## Lake Oroville Spillways Emergency Recovery

# Board of Consultants Memorandum No. 14 – December 1, 2017

## Board of Consultants Memorandum

SUBJECT: Memorandum No. 14

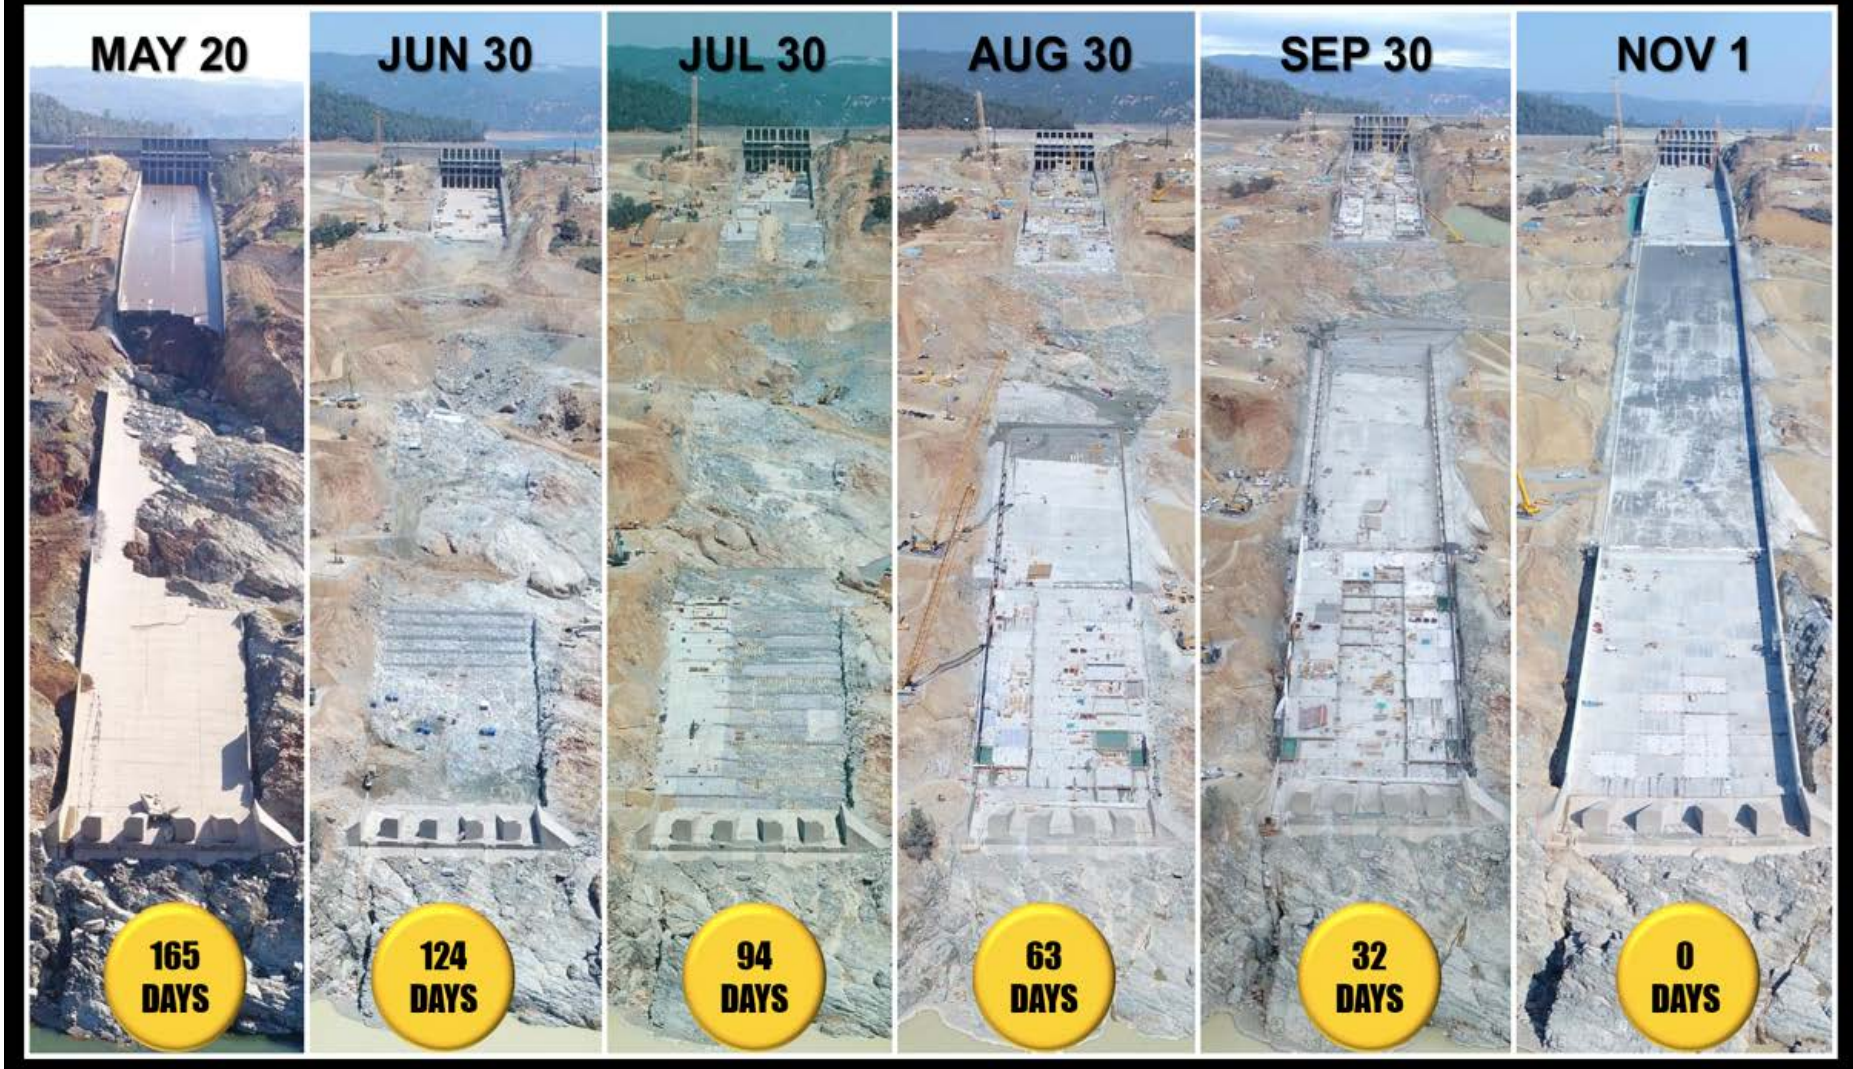
The BOC congratulates the Design Team, the Contractor, and the regulatory agencies for expediting the project and completing the required construction work by the November 1, 2017 deadline. The completed work is of high quality and the FCO with its interim features is ready for service during the 2017-2018 wet season, if needed. Photographs showing construction progress of the reconstructed FCO spillway are shown in Figure 1.
